# PRODUCT CHANGE NOTIFICATION

### Bourns® Model SRN4018 Series Semi-shielded Power Inductors

#### *Package Tape Carrier Modification*

### Existing Package Tape Carrier:

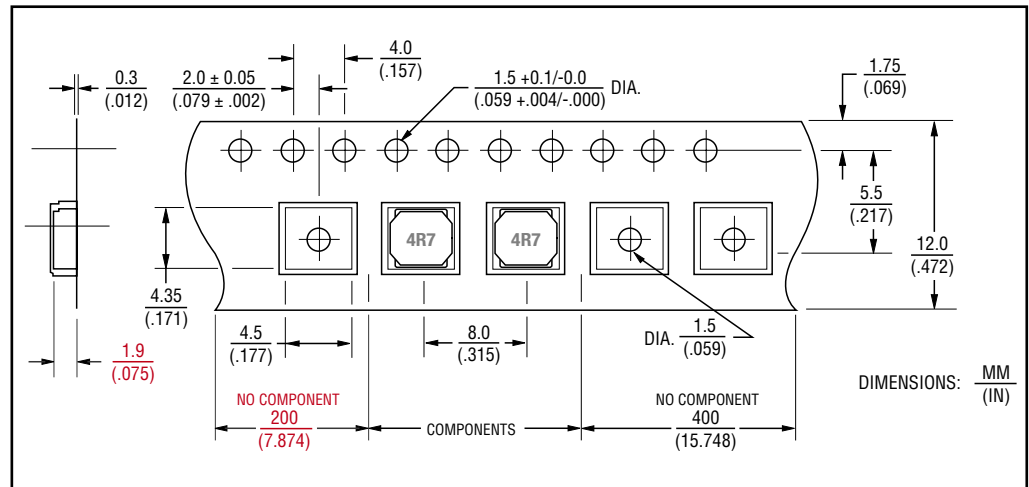
1) No strengthening ribs

2) 200 mm min. tape leader and 1.9 mm pocket depth

### Modified Package Tape Carrier:

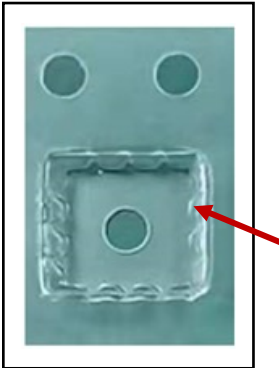
1) Strengthening ribs at pocket

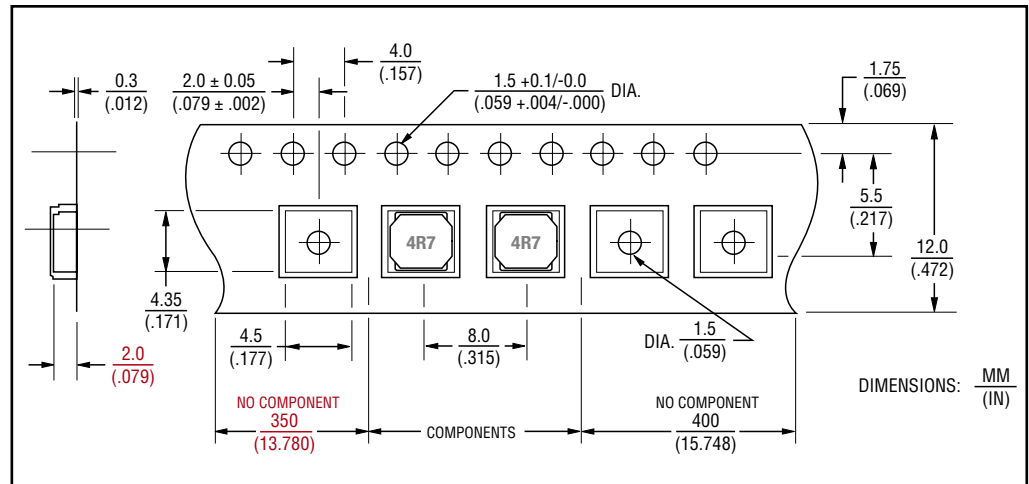
2) 350 mm min. tape leader and 2.0 mm pocket depth
